Re: BusConnects Belfield/Blackrock to City Centre Core Bus Corridor Scheme

Bus Connects - Belfield Blackrock Scheme

ABP-313509-22

#### Submission /observations:

From Sheet 21 of 24 - Bus Connects General Arrangement Drawings:

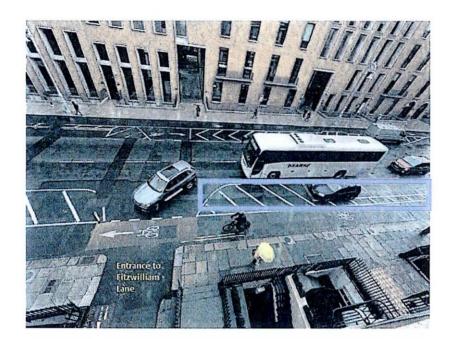
The proposed new location for the new Bus Stop is at the junction of Fitzwilliam Street Lower & Fitzwilliam Lane.

It is replacing the current no parking/chevron area which was installed to protect cyclists & pedestrians when the existing cycle lane was opened.

To quote the Road Safety Authority awareness campaign — "if you can't see the driver, the driver can't see you"

Proposed Bus Stop

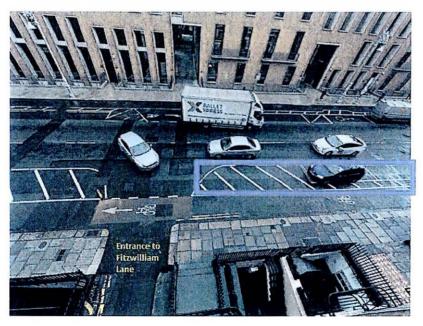
Below photos mark the Proposed Bus Stop location which would replace the current chevron no parking area (plus car spaces). This will create an extremely dangerous blind spot for traffic turning into Fitzwilliam Lane from car traffic in both directions when busses are stopped. Motorists will be unable to see both cyclists and pedestrians.

The existing Inbound Bus Stop on Baggot Street Lower is in a safer location away from concealed busy traffic junctions. It is also more central to commercial businesses and on a wider street. Safer for both cyclists and pedestrians.

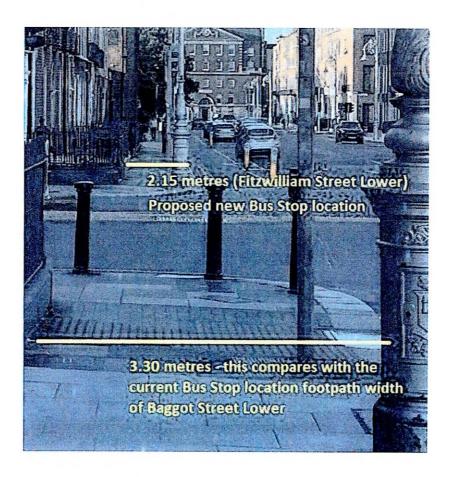
Current Inbound Bus Stop - Lower Baggot Street footpath width: 330cm

Proposed relocated Inbound Bus Stop – Fitzwilliam Street Lower footpath width: 215cm.

This is over 1 metre narrower and one of narrowest footpaths in the area. The street itself is too narrow to widen footpaths and allow for all the planned traffic lanes.

Fitzwilliam Street Lower is less suitable than the current location of Lower Baggot Street for commuters to wait for buses as it will obstruct pedestrians.

## 3. Bus Shelters - South Georgian Core

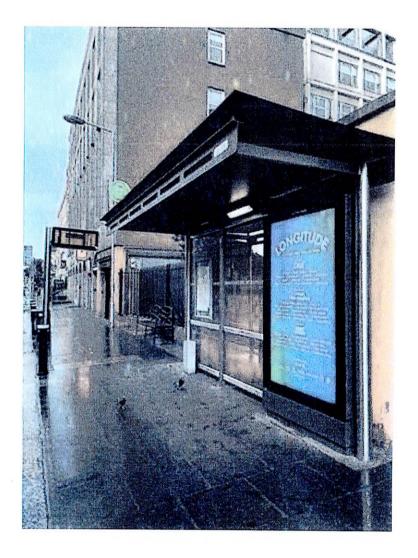
Previously Bus Shelters have not been used in the South Georgian Core, particularly fronting Georgian Buildings.

Two shared landing bus stops are now proposed in the plan:

- a. Fitzwilliam Street Lower Inbound
- b. Baggot Street Lower Outbound

These are entirely inappropriate to historical Georgian Dublin.

We in the SGCRA are trying to remove inappropriate street furniture and signage in the South Georgian Core. Their installation would be a regressive step aesthetically.

Image 3.9: Sub-section SAS1 Route Options extracted from 'Dun Laughaire to City Centre Core Bus Corridor Options Study – Feasibility and Options Assessment'

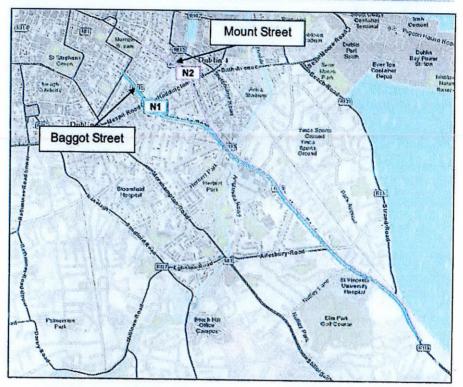
The Environmental Impact Assessment Report (EIAR) did not take this into account when comparing their N1 and N2 options of the alternative route via Mount Street rather than Baggot Street.

This fails to recognise the historical and architectural significance of the South Georgian Core and the Georgian Mile. Indeed, it violates DDCs own city plan.

This has not been reflected in the EIAR and if taken into consideration, the N2 Mount Street route would be more suitable.

Image 4.8: Typical BusConnects Road Layout (PDGB)

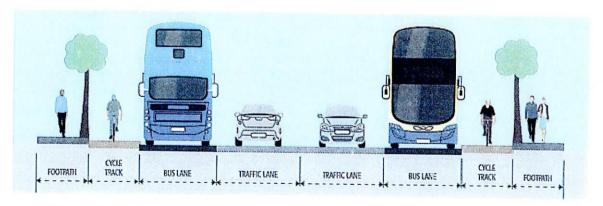
The Environmental Impact Assessment Report (EIAR) did not consider the option of dividing Buses or Cycling on alternative routes. They have created a highway of all modes of transport been routed on a single route.

We feel this creates far too much pressure on one single route and therefore the roads selected are unfairly taking the burden of traffic.
